SERVICE BULLETIN

N° **139-714**

ATA 25 - LIFE RAFT CABLES RETROMOD

This Service Bulletin is issued in order to provide the necessary instruction on how to perform the inspection of the cables P/N 3G2560V02032 and the installation of the LH-RH liferaft cables retromod P/N 3G2560P02011.

Figure 1

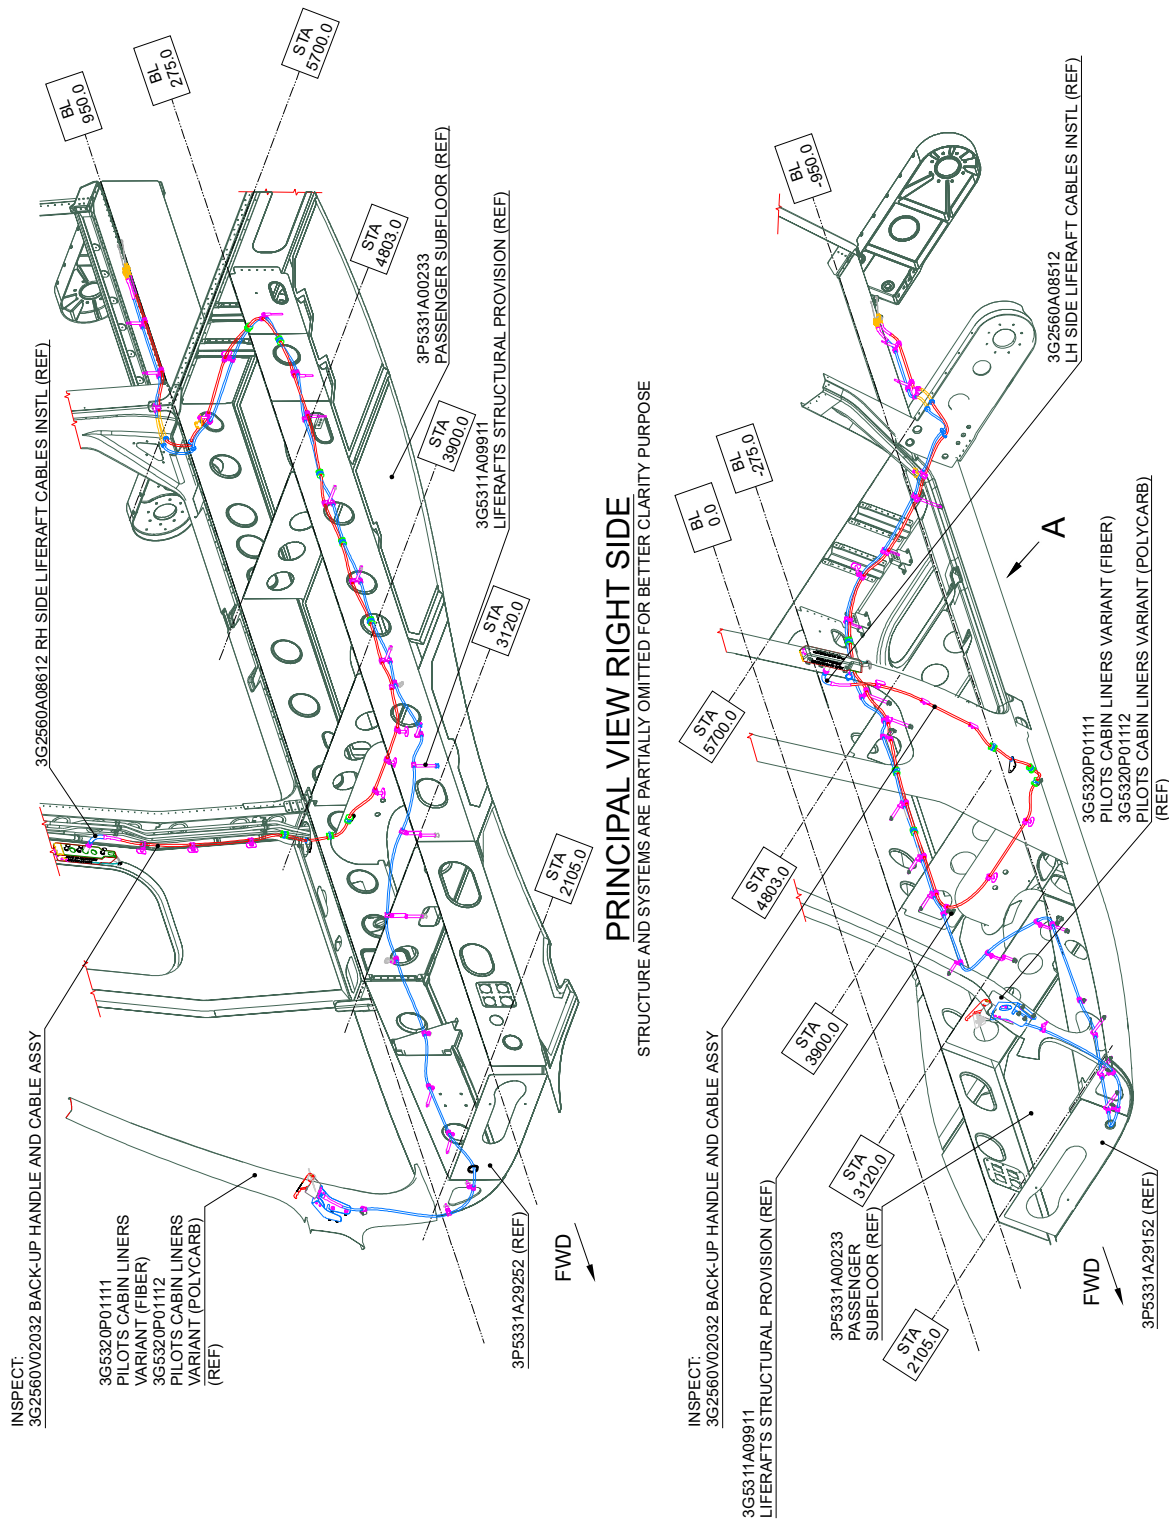
- 2.1 With reference to Figure 1 Principal view right side and Principal view left side, inspect the back-up handle and cable assemblies P/N 3G2560V02032 to check if there is water and/or condensation inside the transparent sleeving that protects the metal cable.

- and/or AMP DM 39-E-25-62-04-00A-520A-K, and with reference to Figure 1 Principal view right side and/or Principal view left side, remove and discard the back-up handle and cable assemblies P/N 3G2560V02032 from the helicopter.

- 2.3 In accordance with applicable steps of AMP DM 39-E-25-62-03-00A-720A-K and/or AMP DM 39-E-25-62-04-00A-720A-K, and with reference to Figure 1 Principal view right side and/or Principal view left side, install the new back-up handle and cable assemblies P/N 3G2560V02032 on the helicopter.

Figure 2

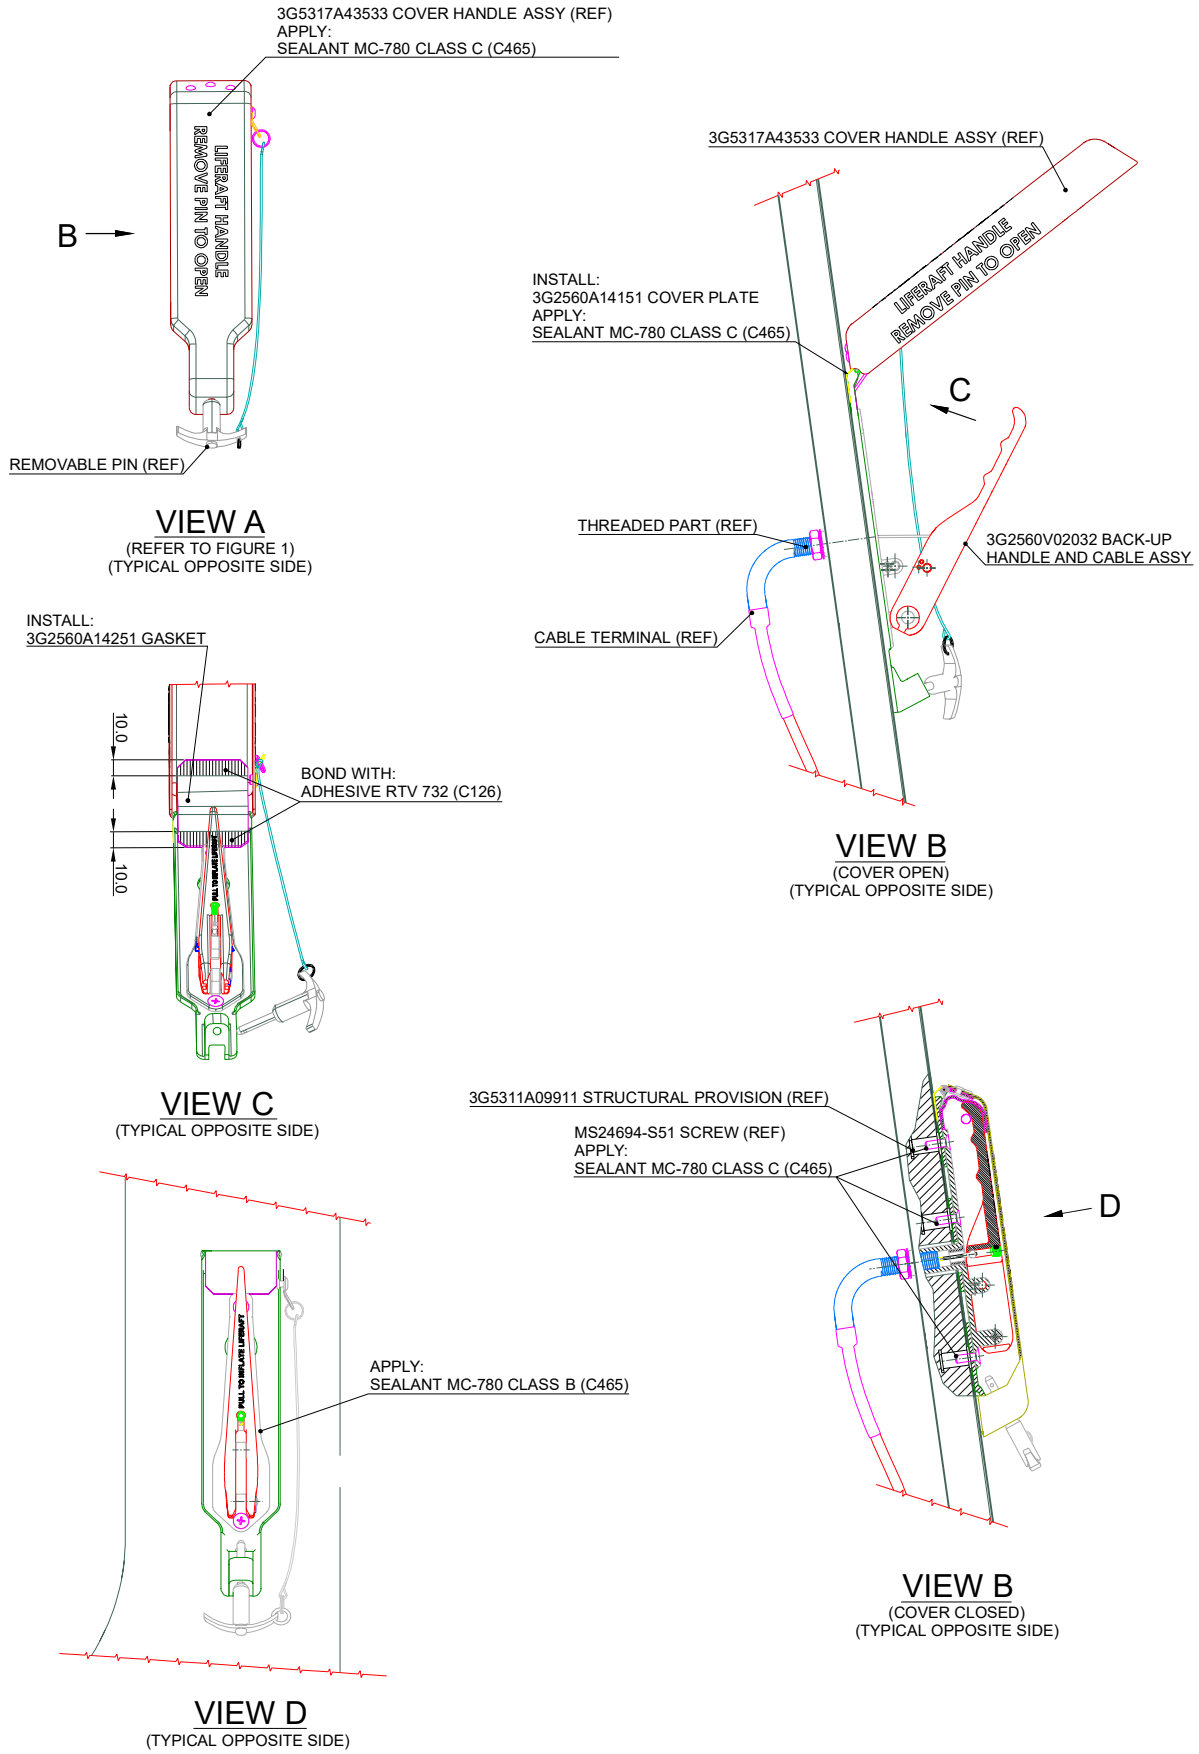
- 3.1 In accordance with applicable steps of AMP DM 39-E-25-62-05-00A-921A-K and with reference to Figure 2 View B, temporarily remove the n°2 cover handle assemblies P/N 3G5317A43533 from the helicopter skin.

- 3.2 With reference to Figure 2 View B, install n°2 cover plates P/N 3G2560A14151 on the helicopter skin by means of sealant MC-780 CLASS C (C465).
- NOTE**

- Apply sealant MC-780 CLASS C (C465) between the cover plate P/N 3G2560A14151 and the cover handle assy P/N 3G5317A43533, and between the cover handle assy P/N 3G5317A43533 and the helicopter skin.

- 3.3 In accordance with applicable steps of AMP DM 39-E-25-62-05-00A-921A-K and with reference to Figure 2 View A and View B, reinstall the n°2 cover handle assemblies P/N 3G5317A43533 previously removed on the helicopter skin. Wet assemble the screws P/N MS24694-S51 by means of sealant MC-780 CLASS C (C465).

- 3.4 With reference to Figure 2 View D, seal all the external perimeter of the back-up handle and cable assemblies P/N 3G2560V02032 with a fillet of sealant MC-780 class B (C465).

- 3.5 With reference to Figure 2 View C, install n°2 gaskets P/N 3G2560A14251 on the n°2 cover handle assemblies P/N 3G5317A43533 by means of adhesive RTV 732 (C126).
